MILITARY SPECIFICATION

VALVES, ANGLE, PRESSURE RELIEF, NAVAL SHIPBOARD, FOR STEAM SERVICE

This amendment forms a part of Military Specification MIL-V-20065D(SHIPS), 8 June 1967.

FIGURE I
RELIEF VALVE CHARACTERISTICS

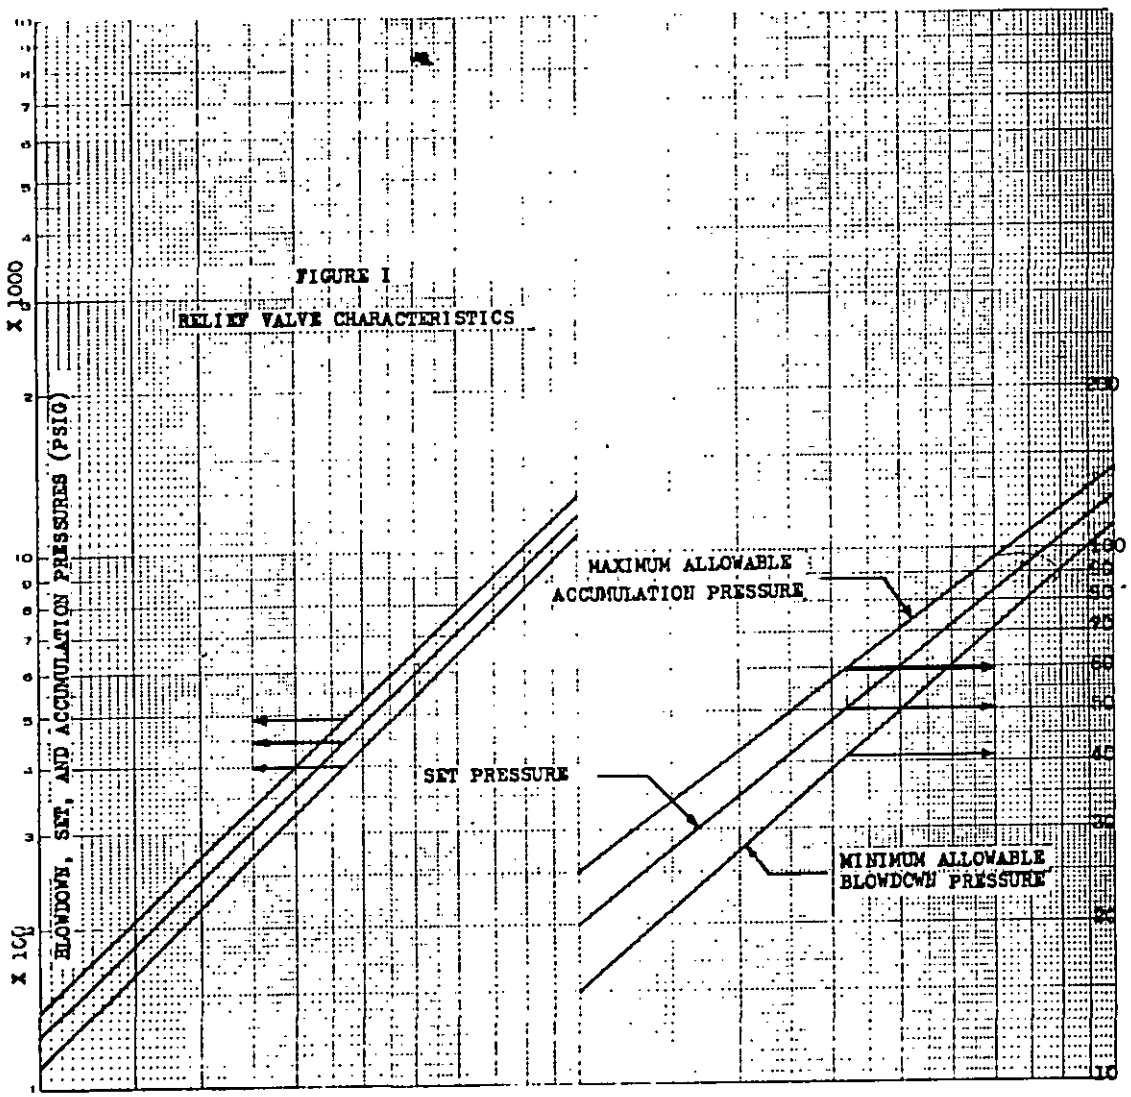
Figure 1: Delete and substitute the attached figure.
